Development Services Staff Report

File Number PL2020-274 – REZONING from R-1 to PMIX, PMIX to RP-4, R-1 to

RP-4 and PRELIMINARY DEVELOPMENT PLAN - Streets of West

Pryor, Lot 7 and Tract C

Hotel

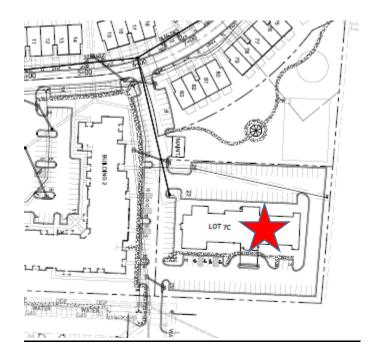
The plan proposes a 3-story, 88-unit hotel. Proposed materials include EIFS, Nichiha Shake (cementitious) shingles and Nichiha Vintage Wood (cementitious) panels in muted tones of cream and brown. Staff is requesting additional architectural detail to include horizontal, vertical material breaks and additional articulation for the west elevation at the time of final development plan submittal. Below are images of the proposed hotel and site layout.

- 4. Additional architectural detail shall be required for the proposed hotel to include horizontal, vertical material breaks and additional articulation for the west elevation, which will be required at the time of final development plan submittal.
